Subject: Proactive Precision Needle Bearing 4307821 Replacement Program

Document Number: TAIB-0887

4th & 6th Gear Needle Bearing Failure – P/N 4307821

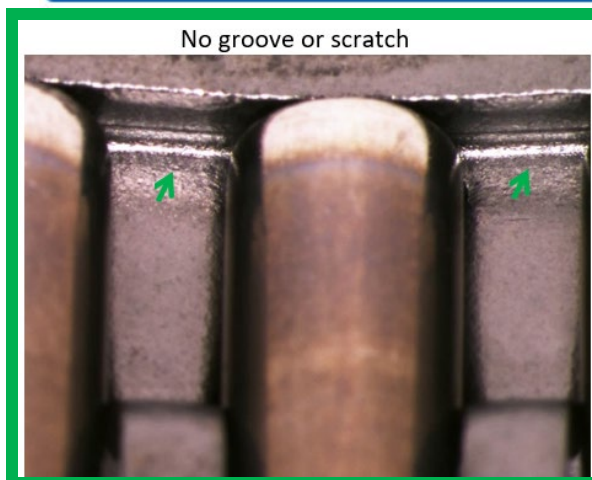
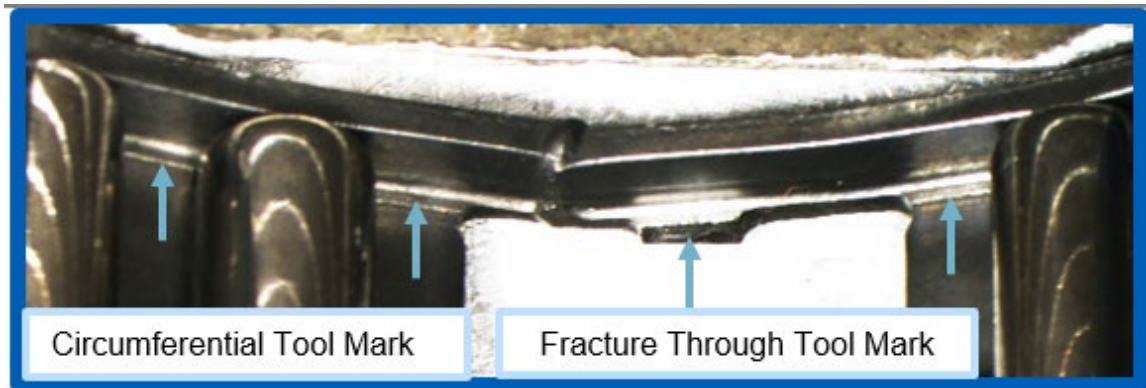
Issue Description: Precision transmission needle bearing 4307821 found in 4th and 6th gear have been found to fail. Driver may experience a 4th or 6th gear shifting complaint, and transmission may have logged various faults. See fault code tables below.

Root Cause: Tool marks on bearing cage bar

Containment/Corrective Action: New bearings that met quality standards were put in place at remanufacturers and Eaton Cummins Automated Transmission Technologies stock at ELC September 18, 2020.

Proactively replace needle bearings and small related parts (K-4507) in chassis; drain and replace transmission oil. Refer to the service procedure video at: <https://bcove.video/2GcE3gx>.
